APPENDIX B: ENVIRONMENTAL ASSESSMENT

APPENDIX E: ADDITIONAL NOISE INFORMATION

Re: Moorebank Recycling Facility - Noise and Traffic Review

Figure 7 Ramp Arrangement showing Location of Barrier

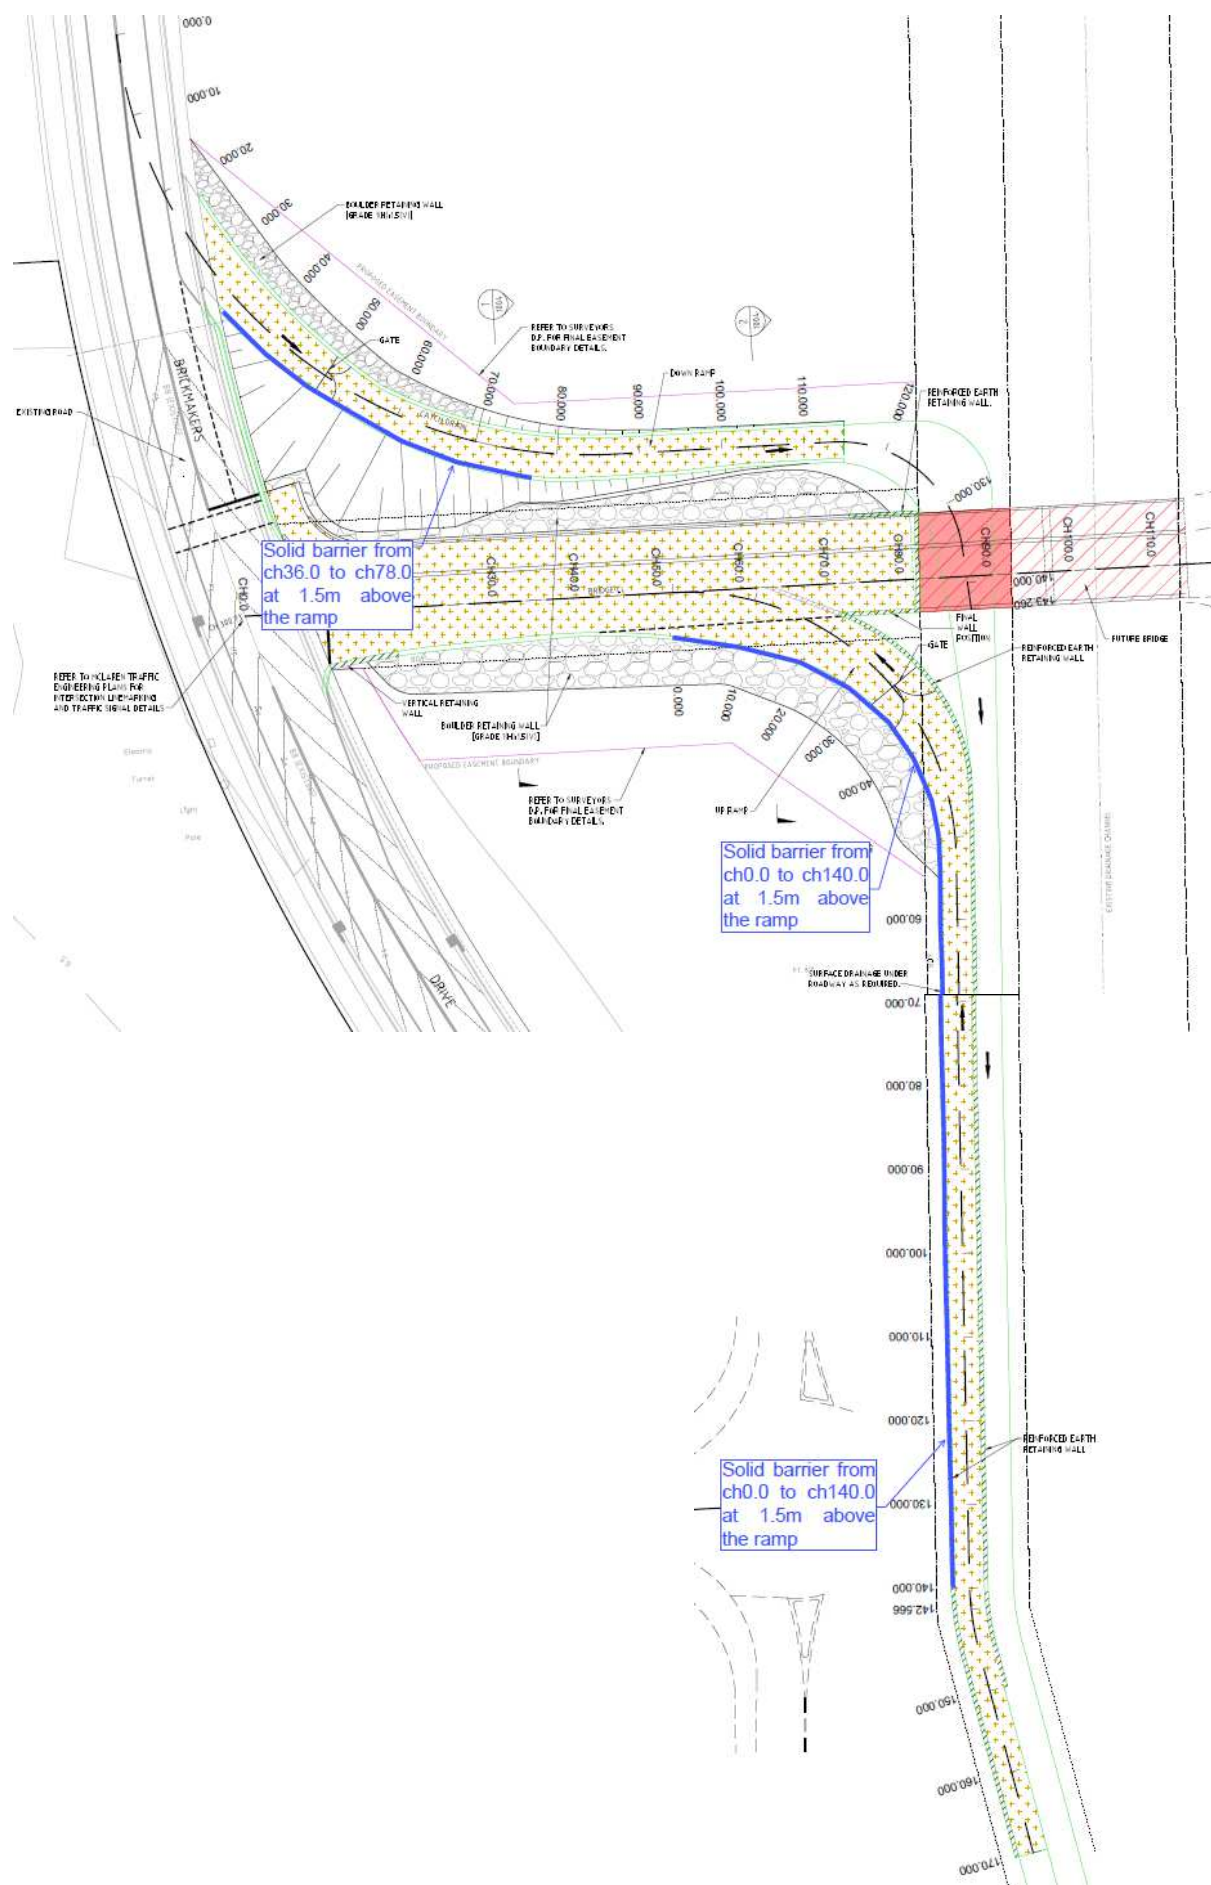
Figure 7 shows the extent of a 1.5m high barrier sufficient to control engine / transmission noise, noting the truck source is split into an engine component (1-1.5m) and exhaust component (3.6m) commonly used in traffic noise assessment. The purpose is to extend the screening along the down ramp from a point close to Brickmakers Drive until the ramp is approximately 1.5m below the level of the proposed new bridge (approx 33m) and along the full length of the up ramp to where it meets the proposed bridge and a location 10m beyond the end of the start of the up ramp (approx 140m).

Figure 9 Barrier Noise Reduction and Resulting Highest Noise Level

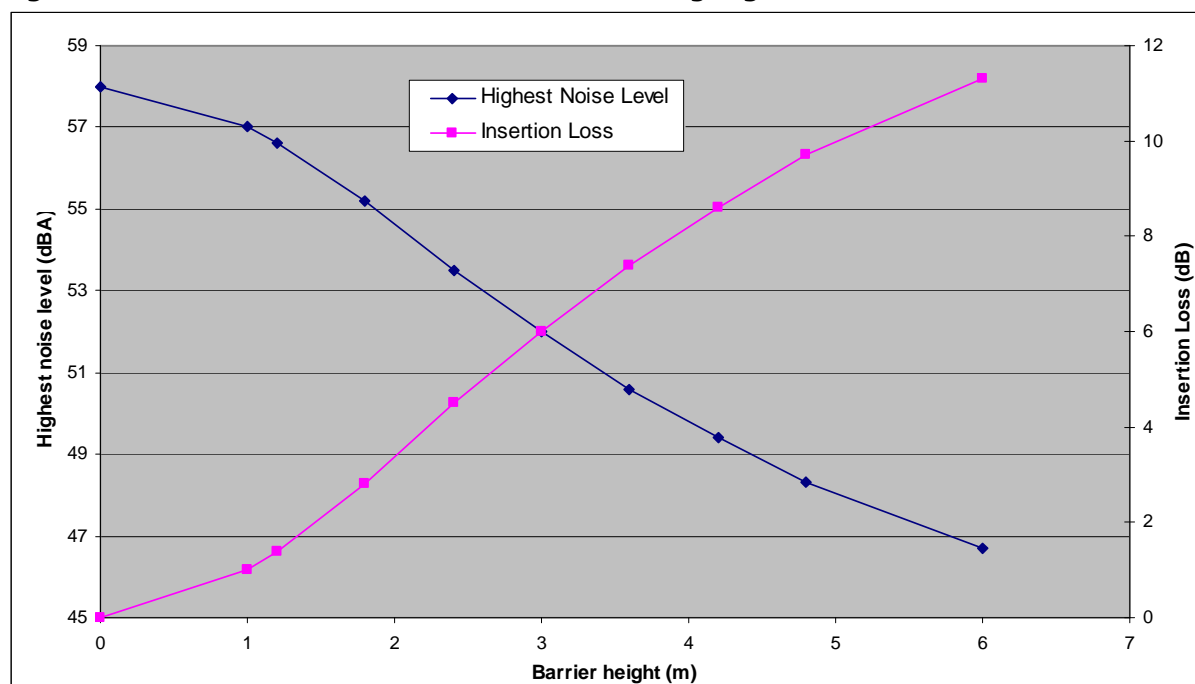
The graph at Figure 9 indicates the height of a barrier needed to control noise to various noise levels (under neutral conditions) at the potentially most affected residential location on the R3 zoned section of the Benedict Sand site.

No barrier is required to meet the industrial criteria. In order to meet an amenity criterion of 55dB $L_{eq,11hour}$, then a low mound/barrier of approximately 1.5m is required. In order to meet an intrusive limit of 51dBA, a higher barrier of up to 3m would be required.

Figure 2 Ramp Arrangement Showing Location of Barrier

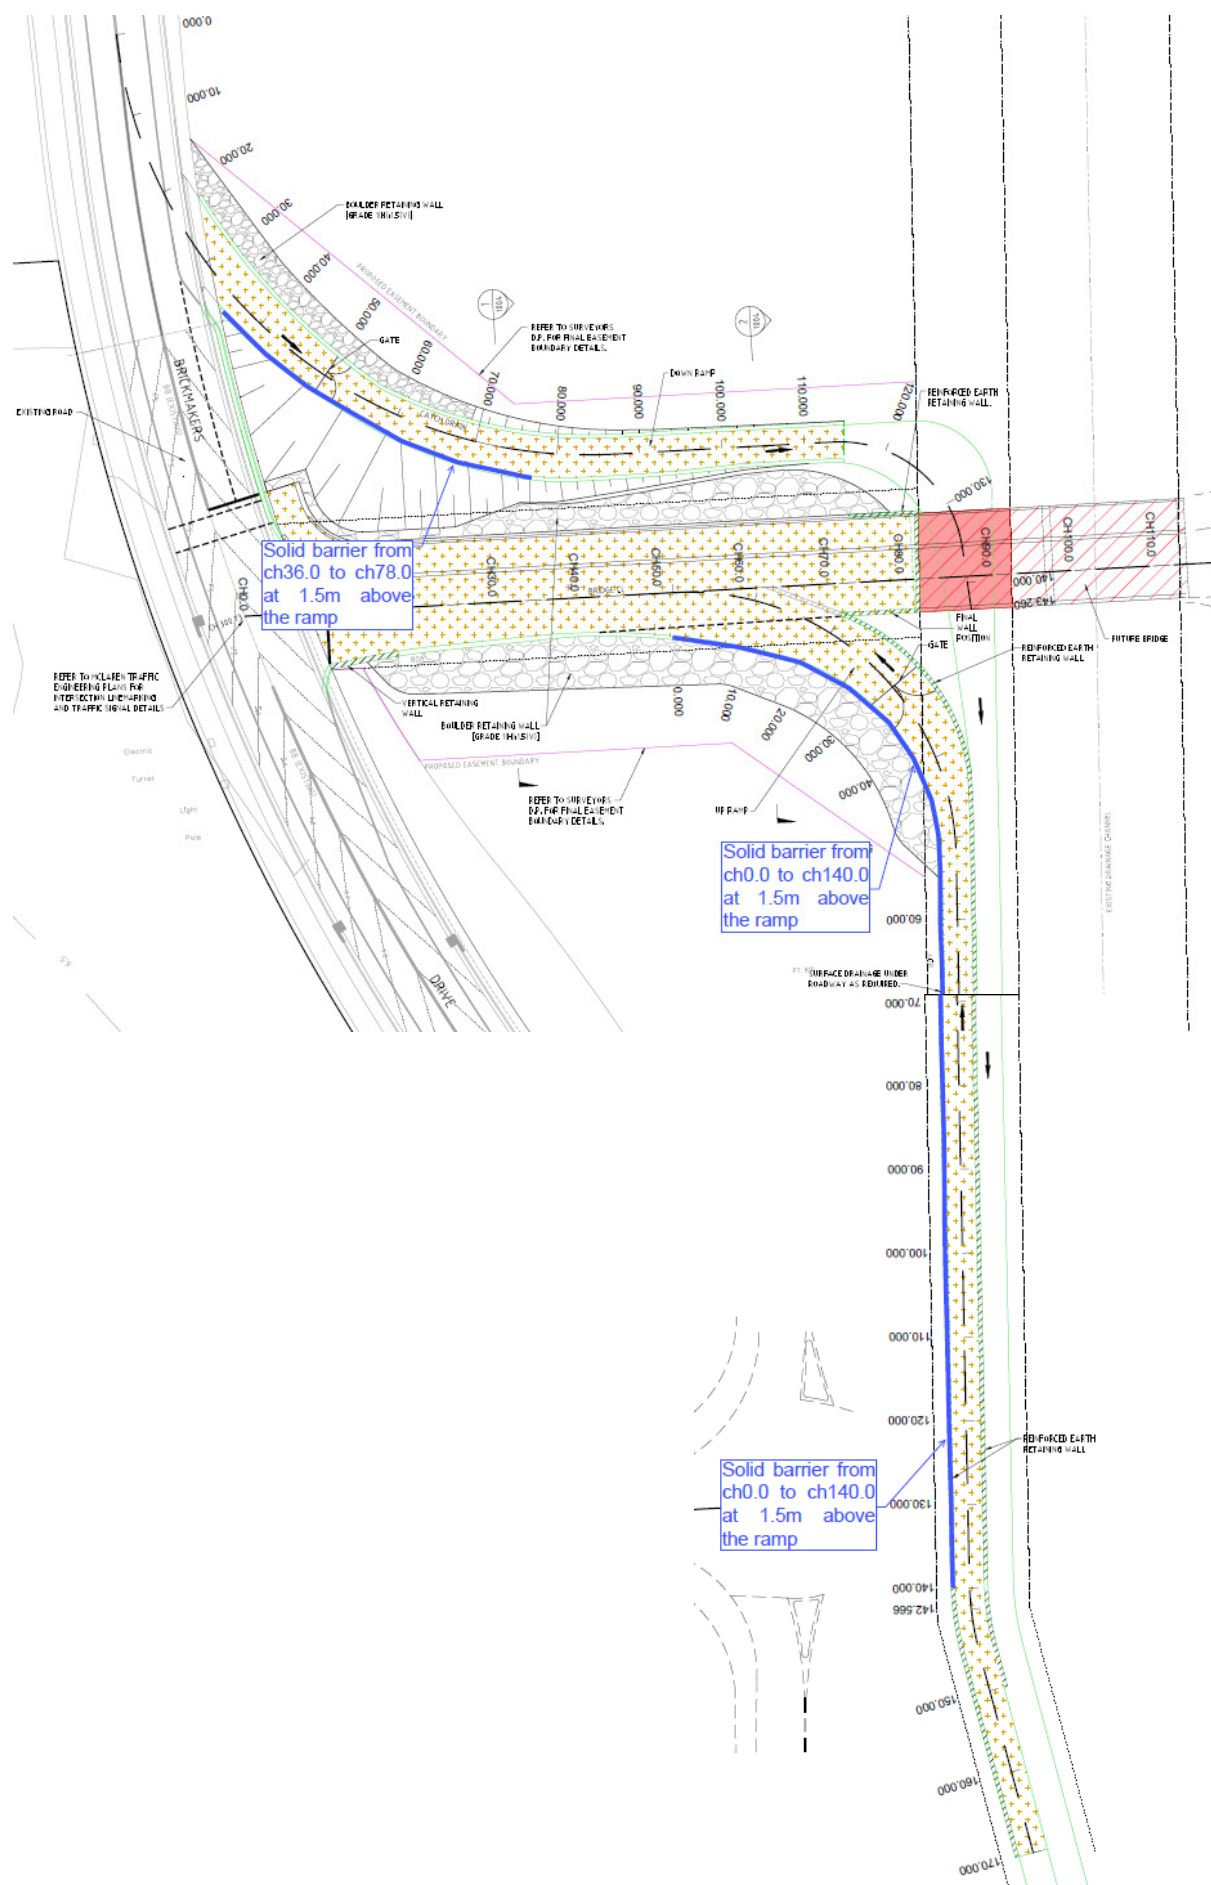
Figure 2 shows the extent of a 1.5m high barrier sufficient to control engine / transmission noise, noting the truck source is split into an engine component (1-1.5m) and exhaust component (3.6m) commonly used in traffic noise assessment. The purpose is to extend the screening along the down ramp from a point close to Brickmakers Drive until the ramp is approximately 1.5m below the level of the proposed new bridge (approx 33m) and along the full length of the up ramp to where it meets the proposed bridge and a location 10m beyond the end of the start of the up ramp (approx 140m).

Figure 4 Barrier Noise Rediction and Resulting Highest Noise Level

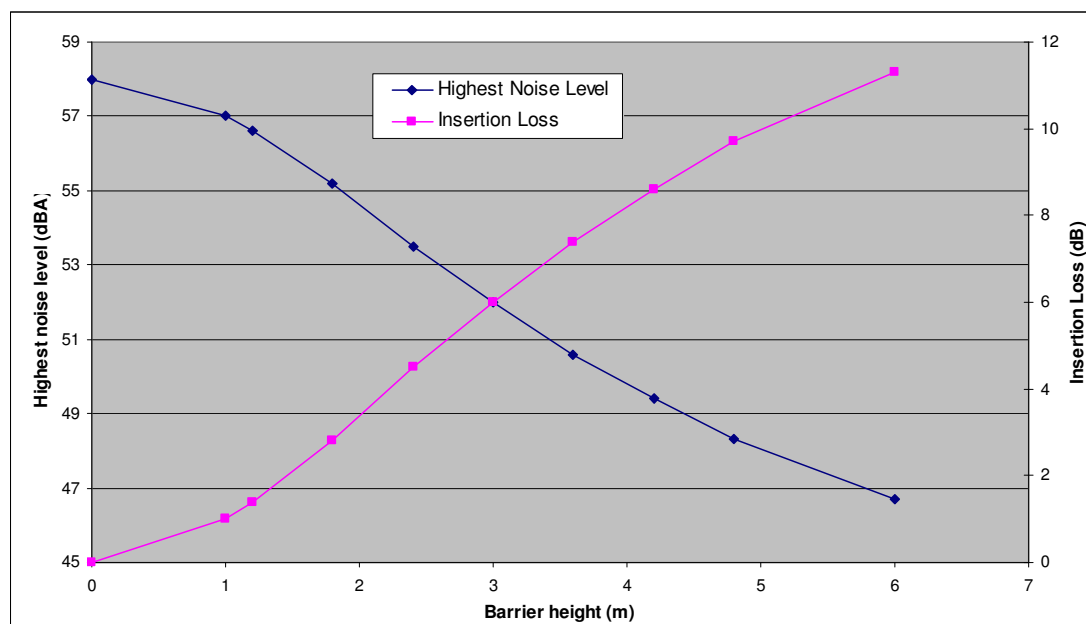
The graph at Figure 4 indicates the height of a barrier needed to control noise to various noise levels (under neutral conditions) at the potentially most affected residential location on the R3 zoned section of the Benedict Sand site.

No barrier is required to meet the industrial criteria. In order to meet an amenity criterion of 55dB $L_{eq,11hour}$, then a low mound/barrier of approximately 1.5m is required. In order to meet an intrusive limit of 51dBA, a higher barrier of up to 3m would be required.
